Tamworth RAC - BUILDING SERVICES CONCEPT SPATIAL MARKUP - REV2

DATE	02/04/24	DRAWN	ED,AB,HZ,HL
SCALE	SEE TITLE BLOCK	CHECKED	RH
SHEET SIZE		APPROVED	RH
PROJECTTAMWORTH REGIONAL AQUATIC CENTRE (TRAC)			
CLIENTCO.OP

Introba LEVEL 12, 77 PACIFIC HIGHWAY NORTH SYDNEY NSW 2060		
TITLEBUILDING SERVICES CONCEPT SPATIALS MARKUP		
PROJECT NO.	DRAWING NO.	REVISION
0010443.000	-	-

ROOF PLAN

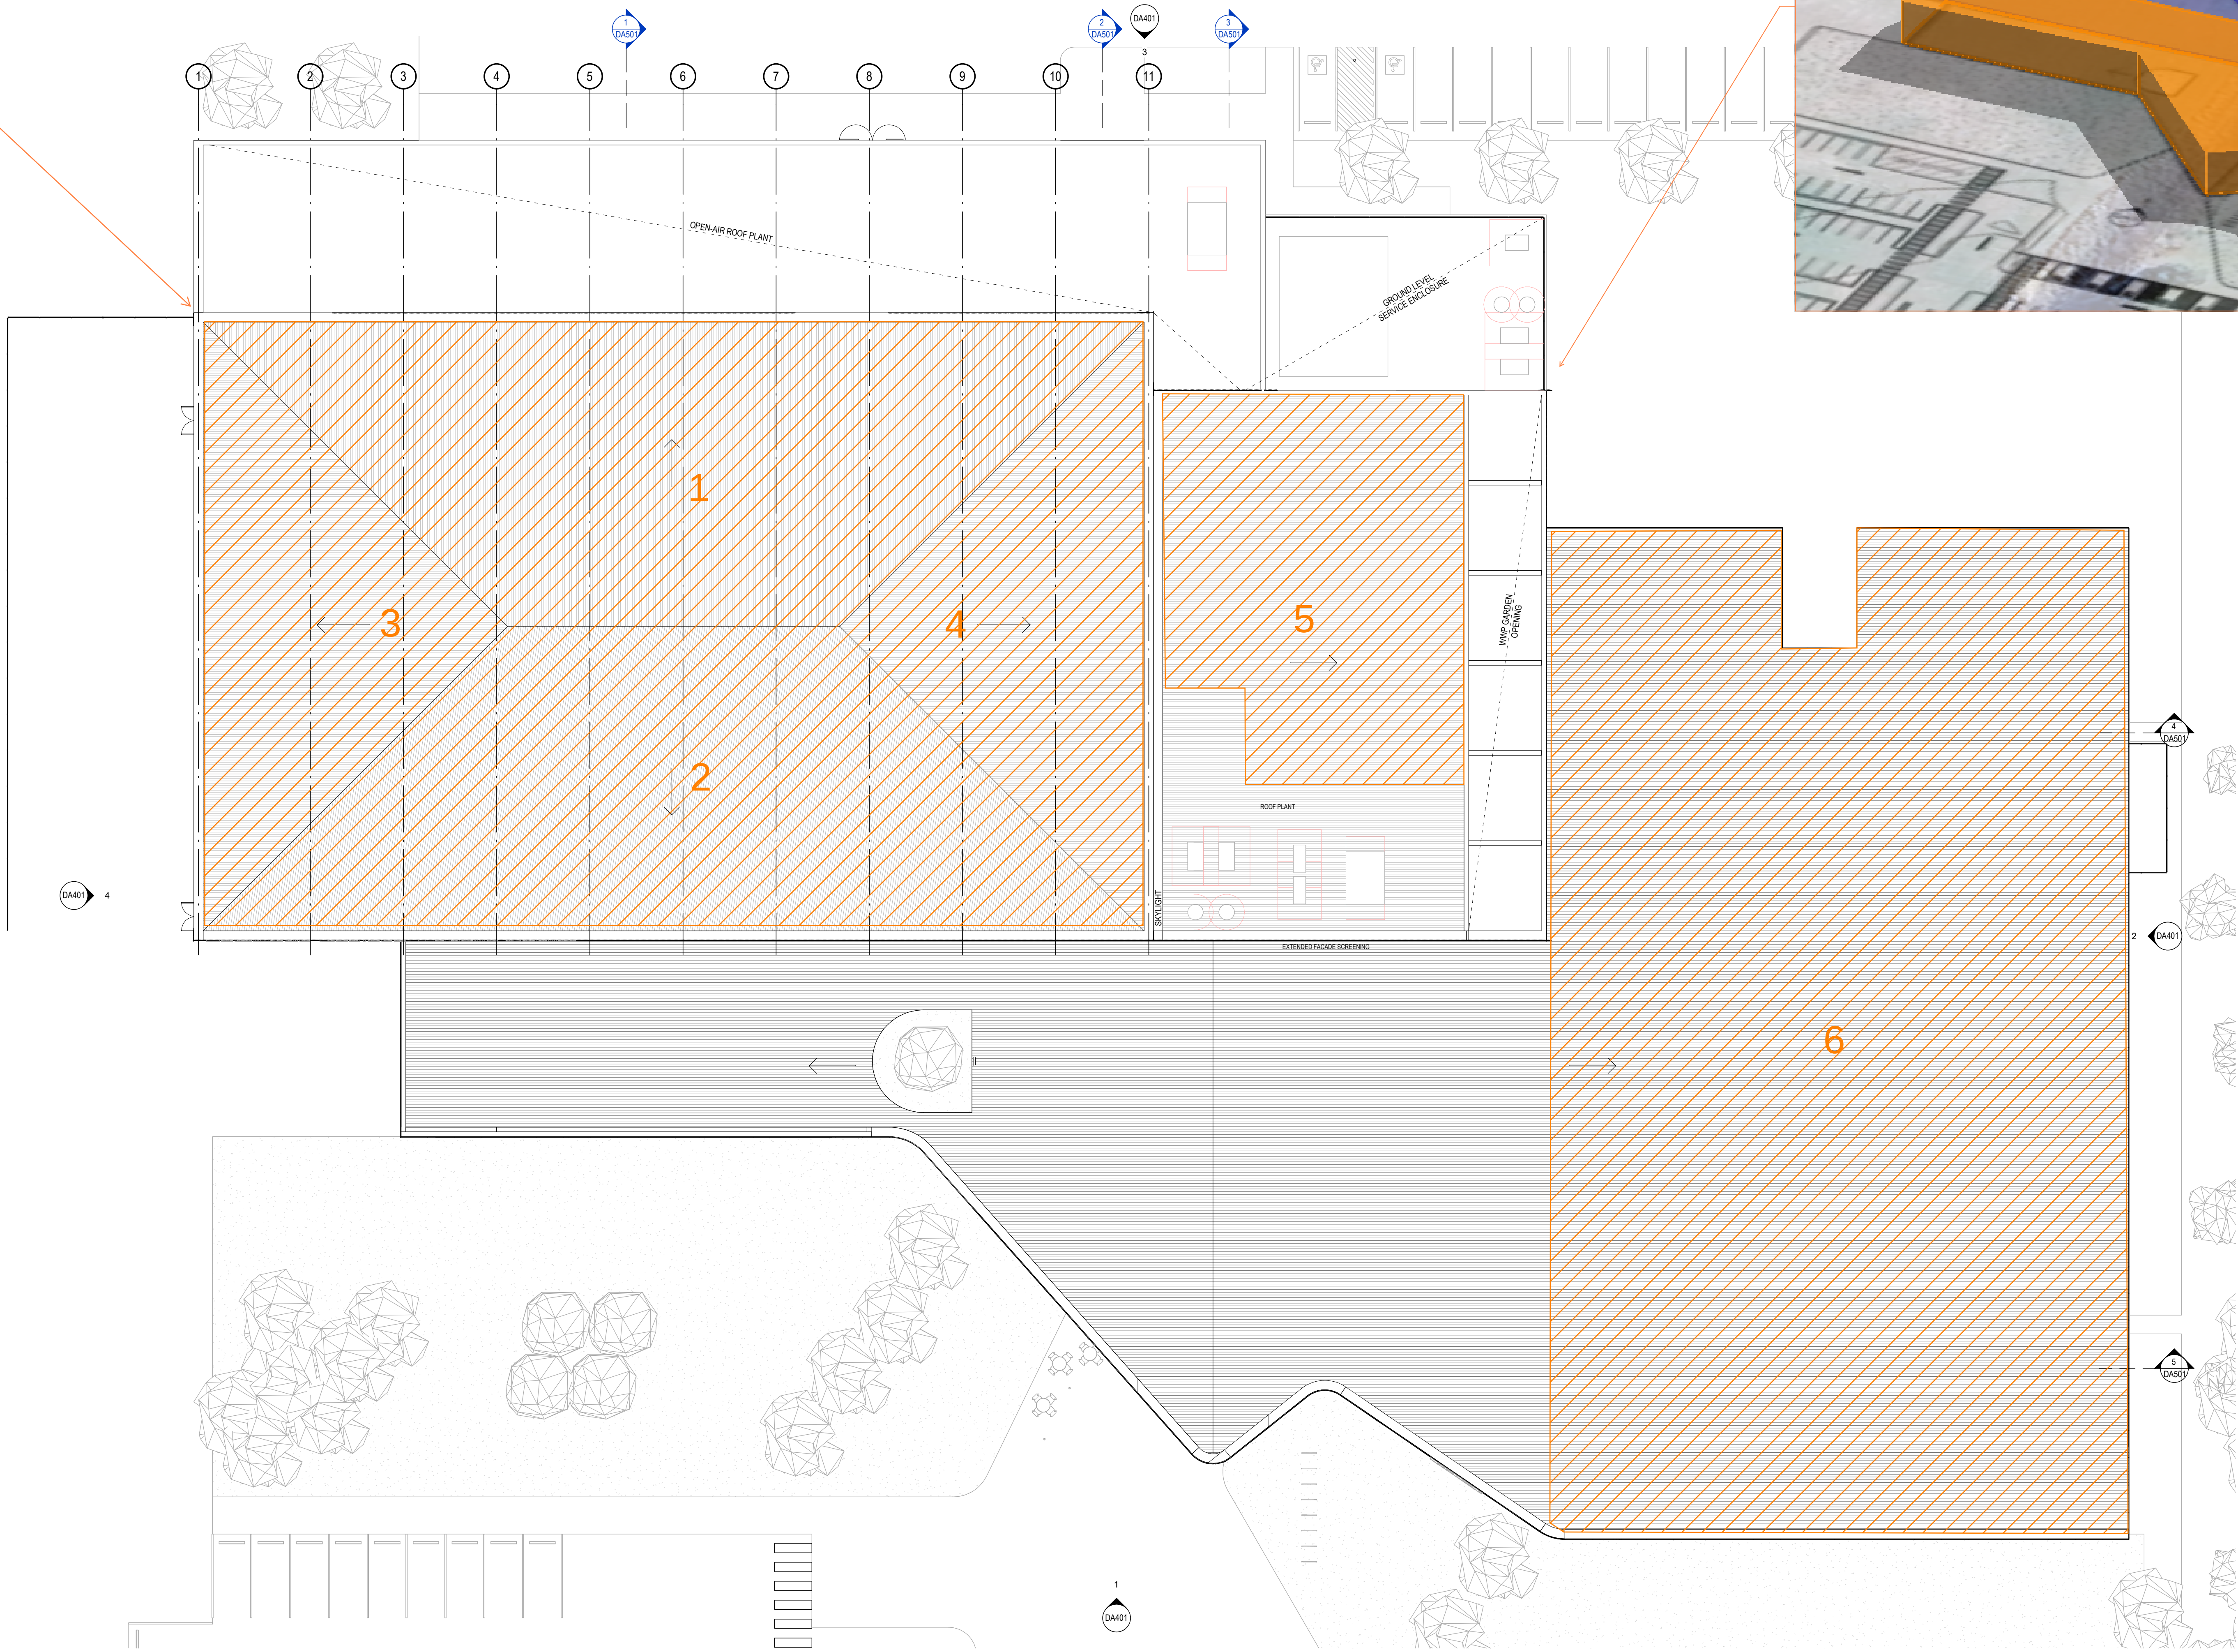
POTENTIAL LOCATION OF PV PANELS ON ROOF. A TOTAL OF APPROX.:
- 186KWP OF PV PANELS CAN FIT ON SEGMENTS 1, 2, 3, & 4.
- 45KWP OF PV PANELS CAN FIT ON SEGMENT 5.
- 271KWP OF PV PANELS CAN FIT ON SEGMENT 6.

SITE PLAN

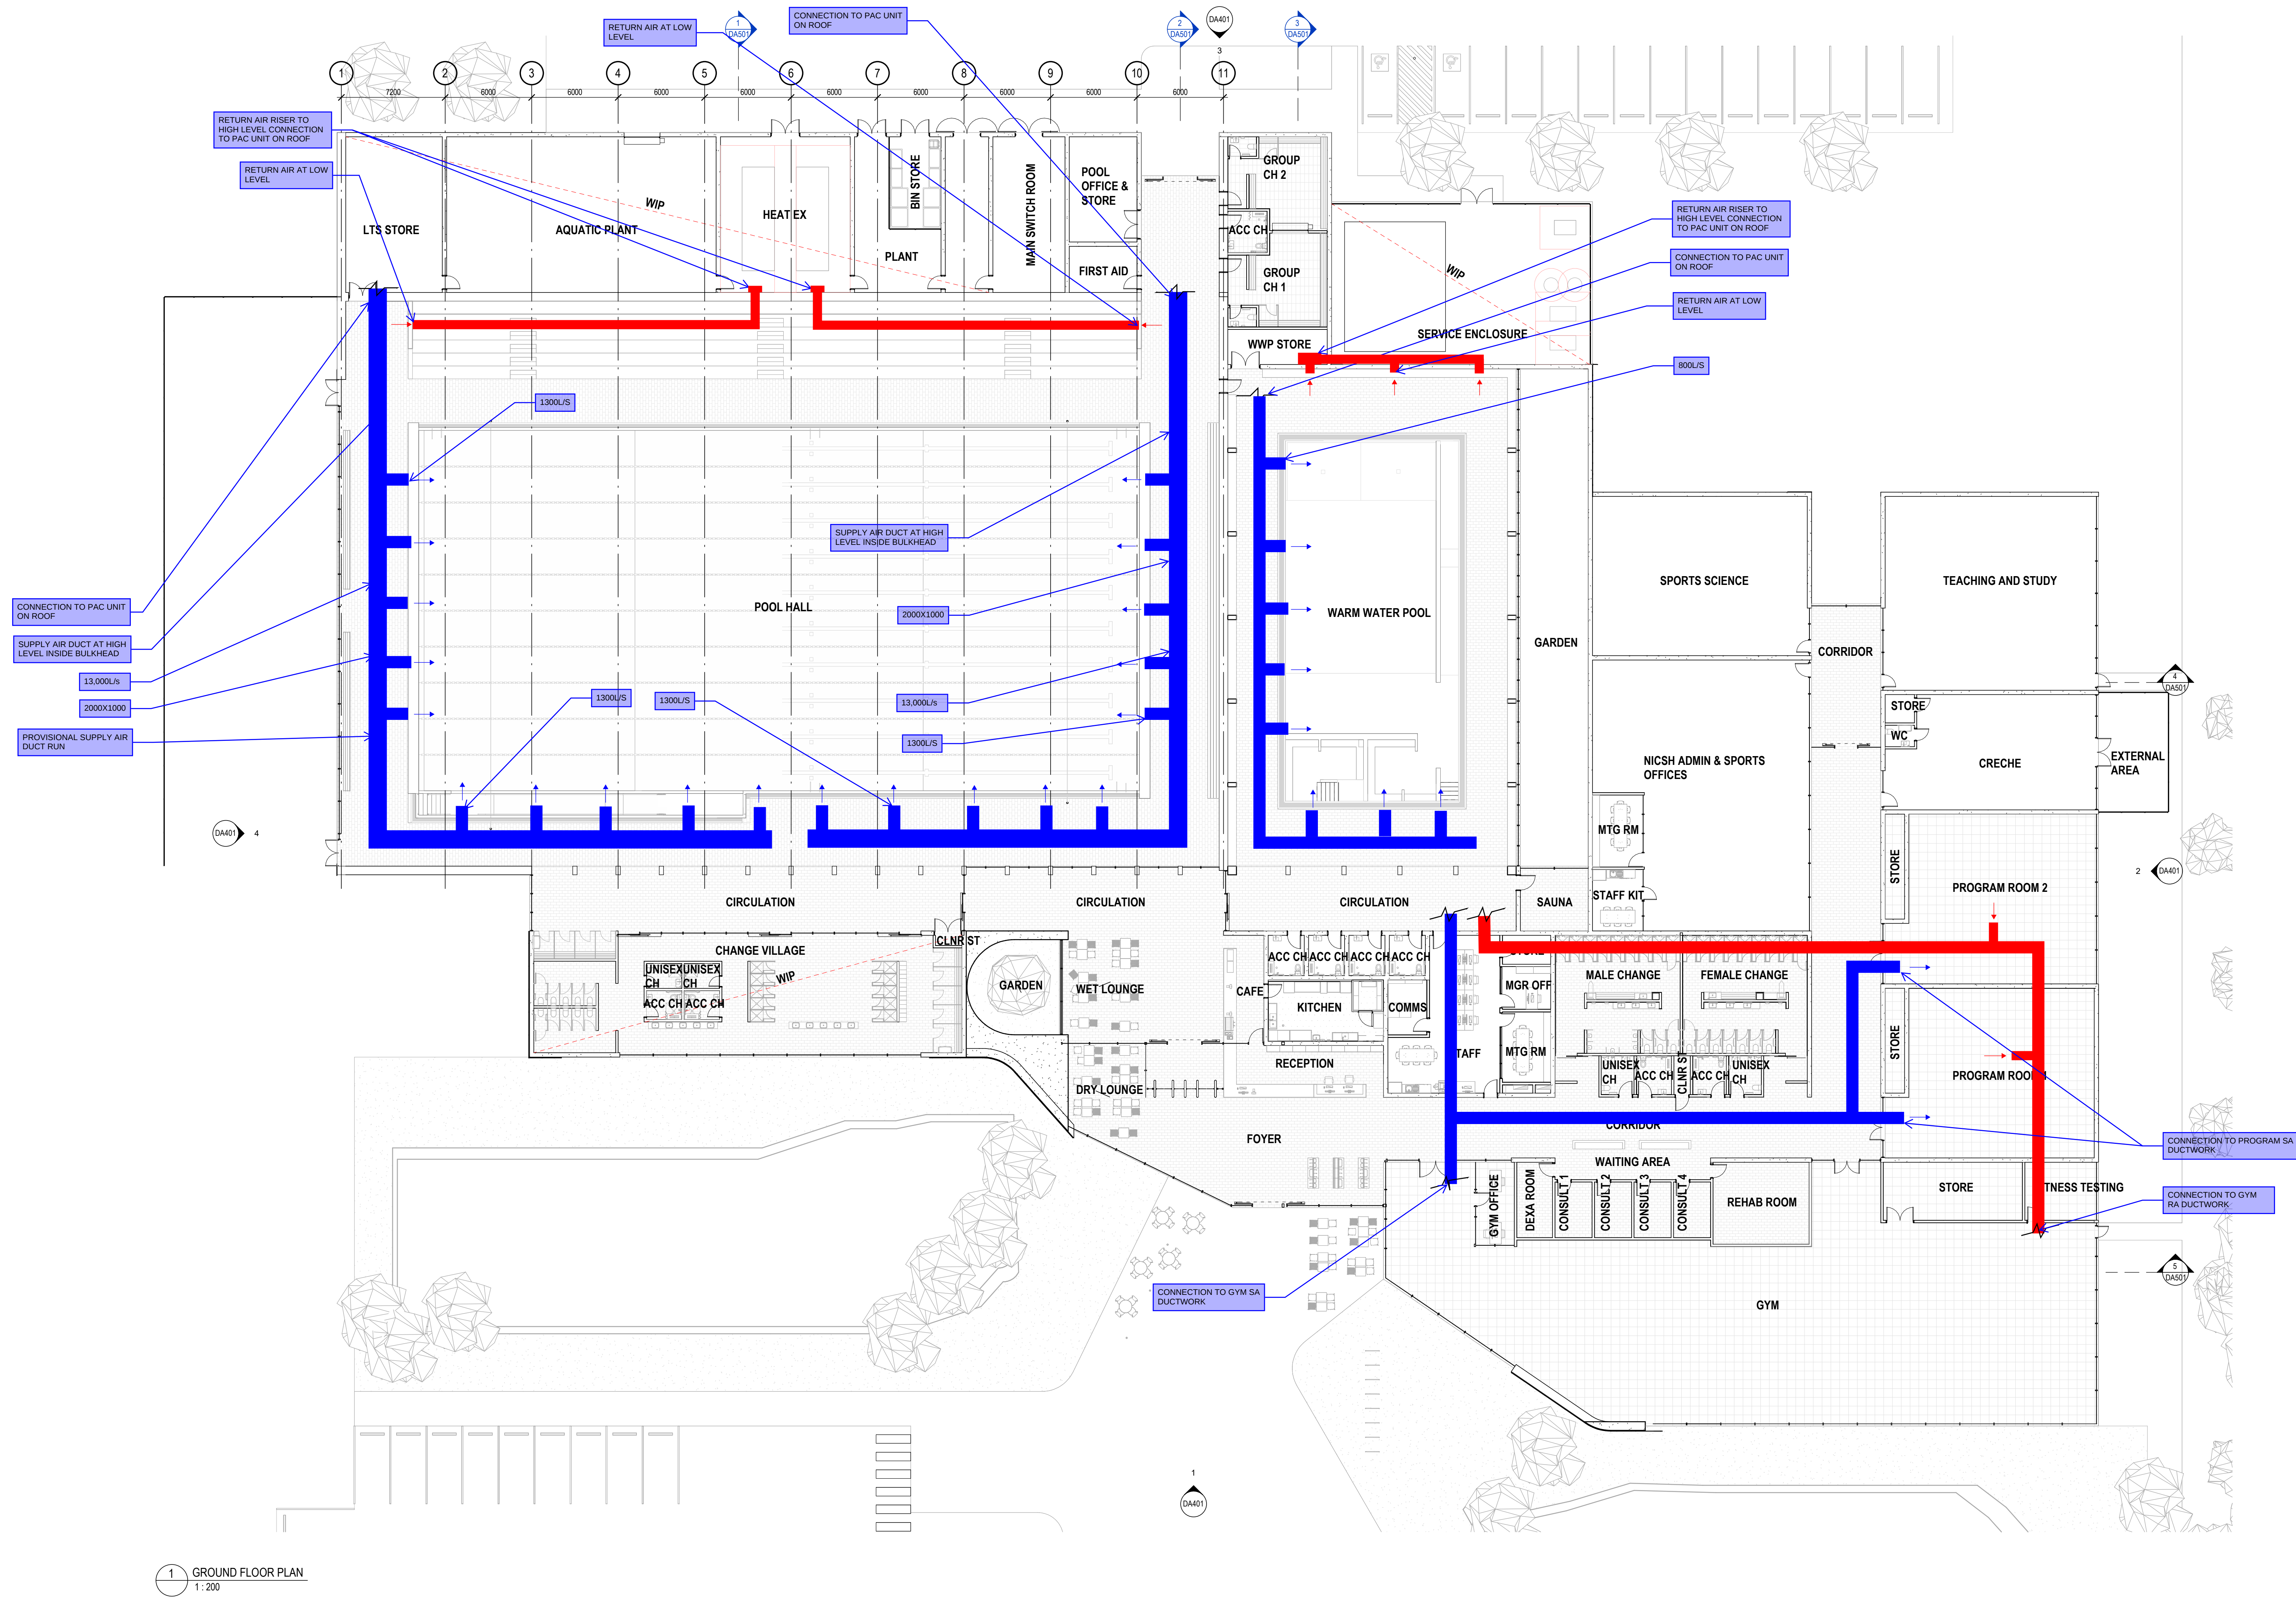
144,000L RECTANGULAR FIRE WATER STORAGE TANK WITH A PARTITION FOR HALF THE REQUIRED CAPACITY. 10m (L) x 6m (W) x 2.5m (H) DIMENSIONS.

OPTION TO USE 2 X CIRCULAR TANKS FOR 50% MAINTENANCE SPLIT

DUAL DIESEL FIRE HYDRANT PUMPS CONNECTED TO WATER STORAGE TANK. 6m (W) x 5m (L) x 2.2m (H).

144,000L RECTANGULAR FIRE WATER STORAGE TANK WITH A PARTITION FOR HALF THE REQUIRED CAPACITY. 10m (L) x 6m (W) x 2.5m (H) DIMENSIONS.

OPTION TO USE 2 X CIRCULAR TANKS FOR 50% MAINTENANCE SPLIT

DUAL DIESEL FIRE HYDRANT PUMPS CONNECTED TO WATER STORAGE TANK. 6m (W) x 5m (L) x 2.2m (H).

NOTE:
OPTIONS WILL REQUIRE A PERFORMANCE SOLUTION AS BOOSTER ASSEMBLY WILL NOT BE AT THE PRINCIPAL VEHICUALR ACCESS TO THE SITE.

GROUND FLOOR
PLAN

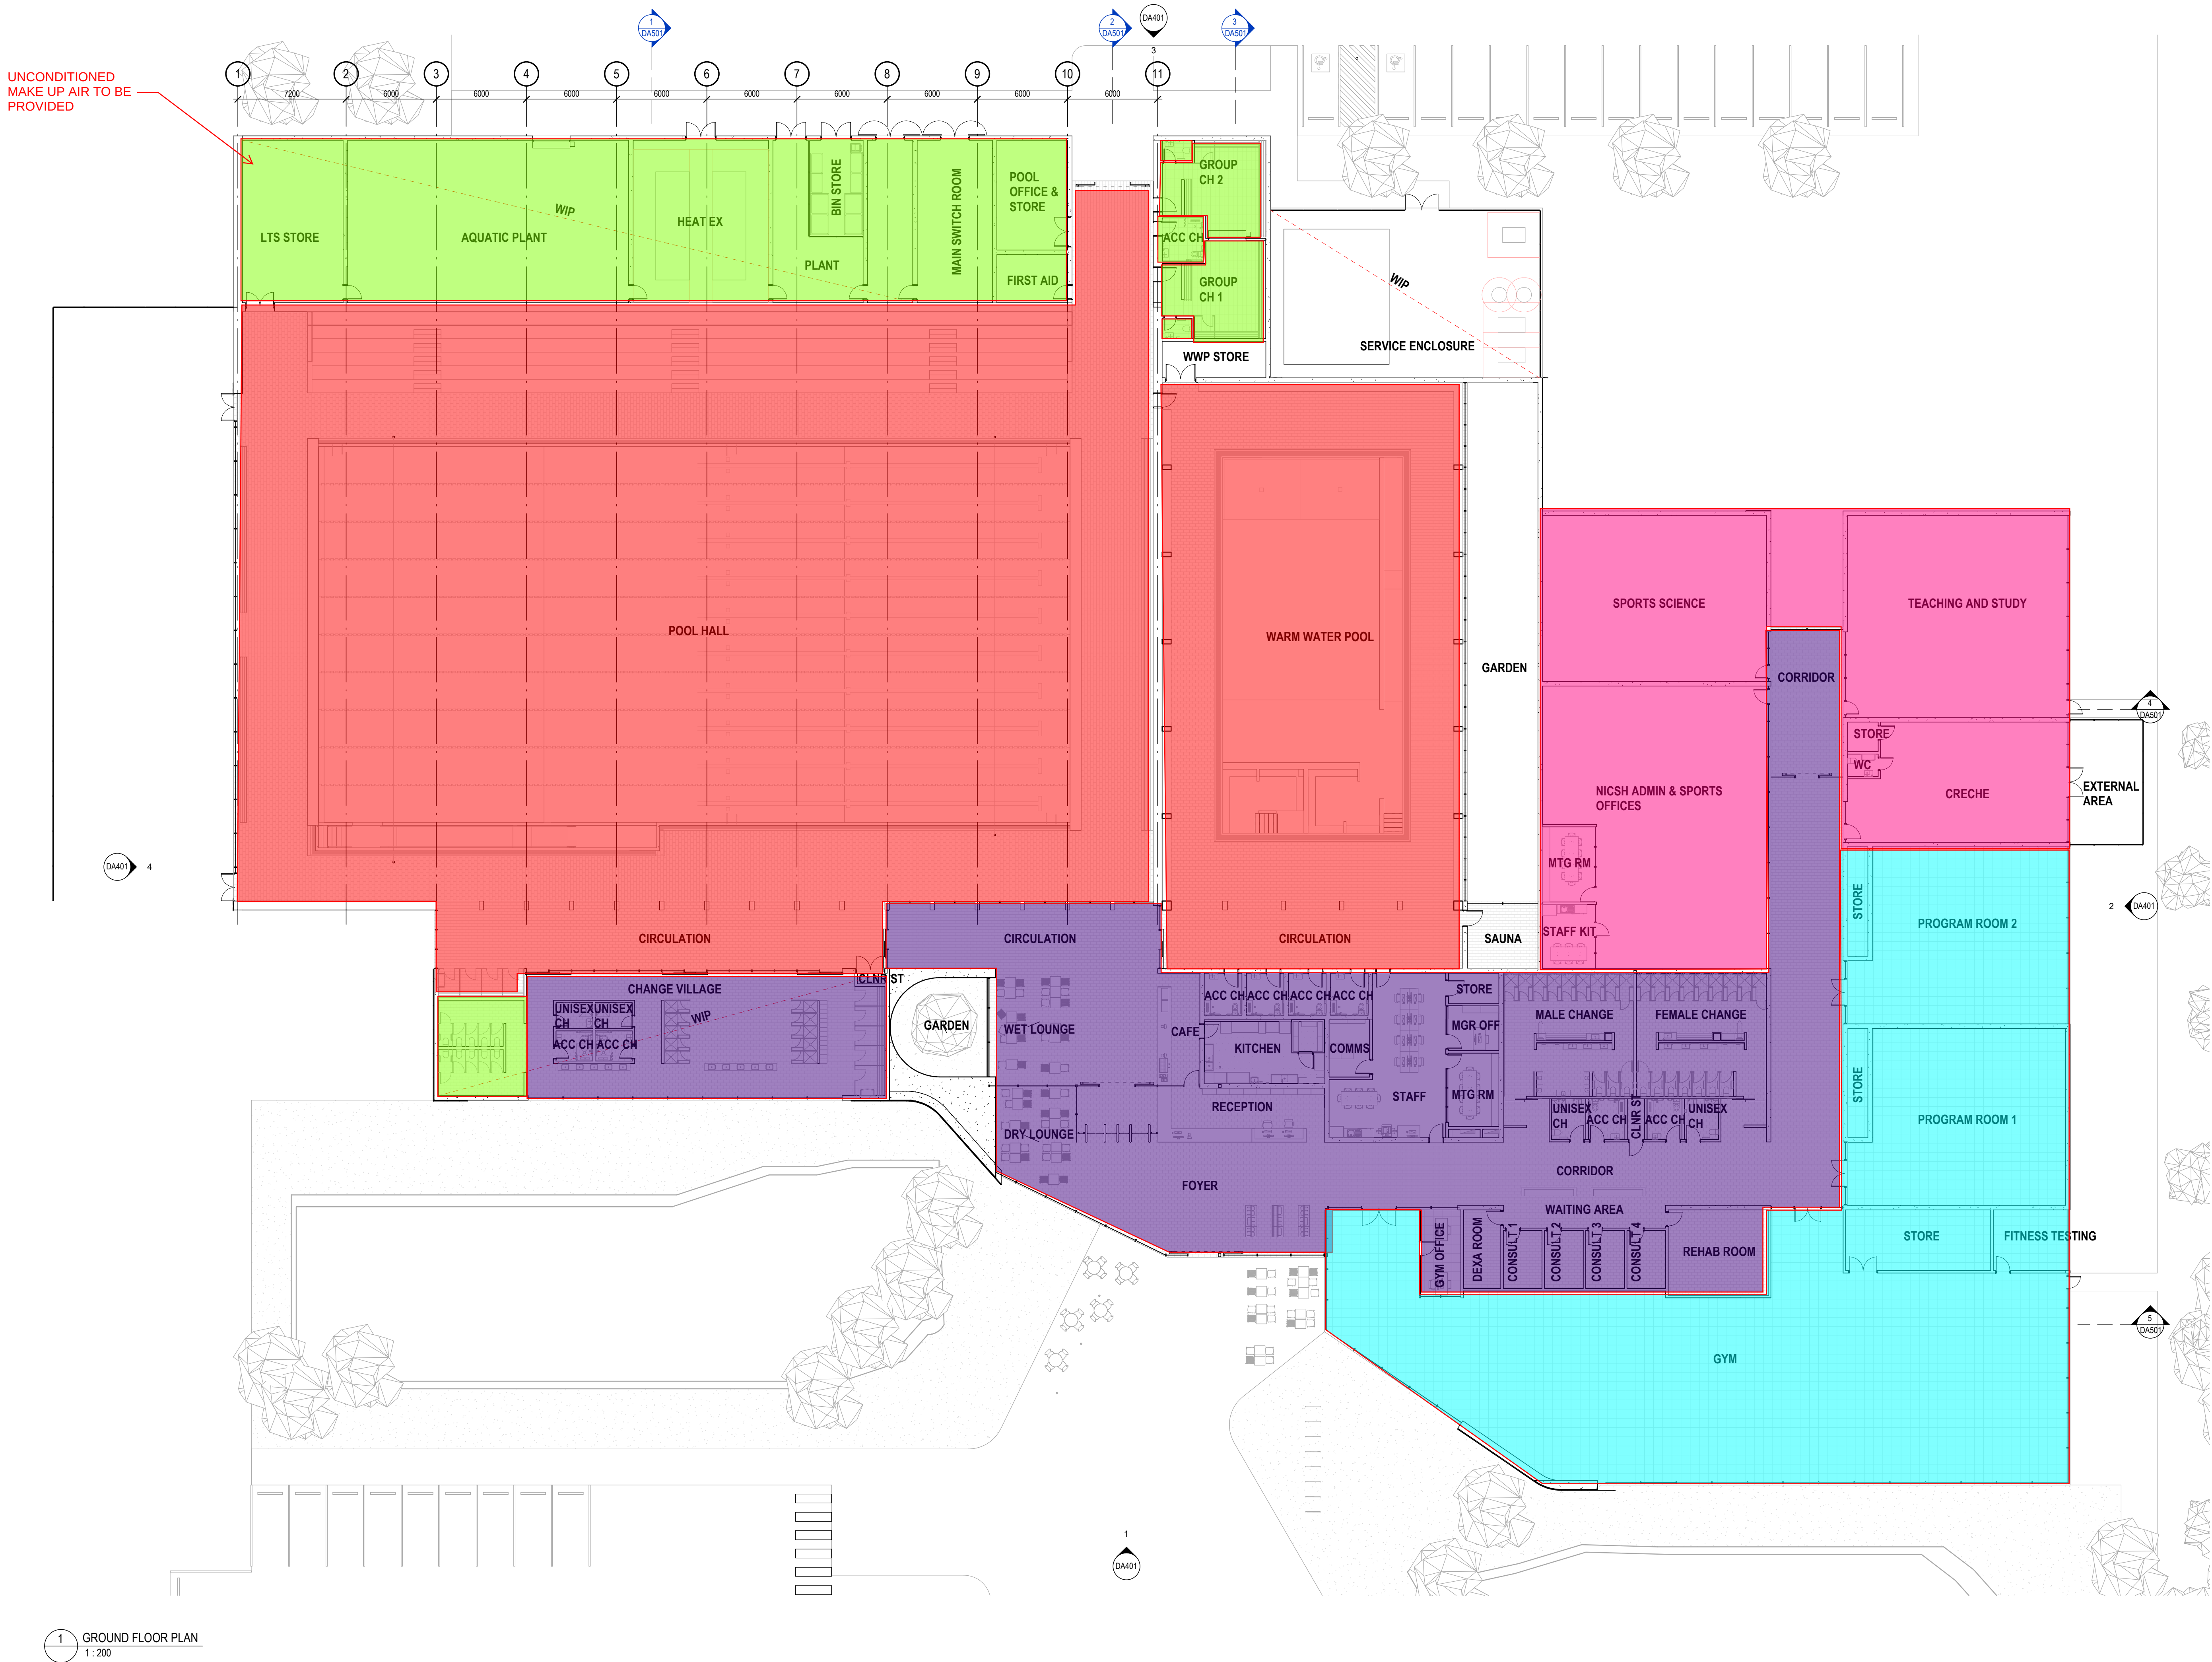
- ADMIN VRF
- Exhaust Only
- Gym PAC unit
- VRF
- Pool PAC
